Development Services Staff Report

File Number	PL2025-277
File Name	Preliminary Development Plan for Les Schwab Tire Center
Applicant	SFP-E, LLC
Property Address	740 NW Ward Rd.
Planning Commission Date	December 11, 2025
Heard by	Planning Commission and City Council
Analyst	Adair Bright, AICP, Senior Planner

The applicant requests approval of a Preliminary Development Plan to allow for the construction of a 6-bay, 8,600-sf. tire center on the property.

Figure 7 – West elevation facing NW Outerview Road

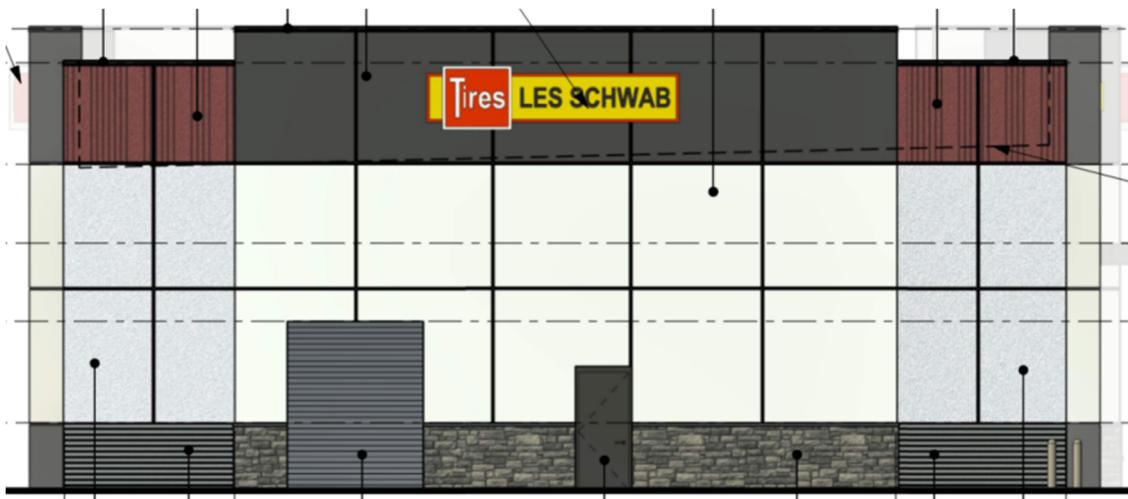
- The applicant has requested a modification to UDO Sec. 8.050.B.4.i.i – Application of windows and doors on commercial storefronts.

- **Requirement** – Fenestrations with clear glass shall occupy no less than 50 percent of the pedestrian view zone. The pedestrian view zone is defined as the 8-foot-tall area of the subject building's primary façade(s) that is between two feet and ten feet above the adjacent sidewalk or ground level.

- **Proposed** – The applicant is proposing the western façade be exempt from this requirement; therefore, containing zero percent of clear glass within the pedestrian view zone.

- **Recommendation** – Staff is supportive of the requested modification. The “storefront” of the subject building is on the southeast corner which is where customers will be entering the facility. The applicant has provided ample clear glass to signify that being the public area. The intent is being met by highlighting the part of the building that is open and available to pedestrians.
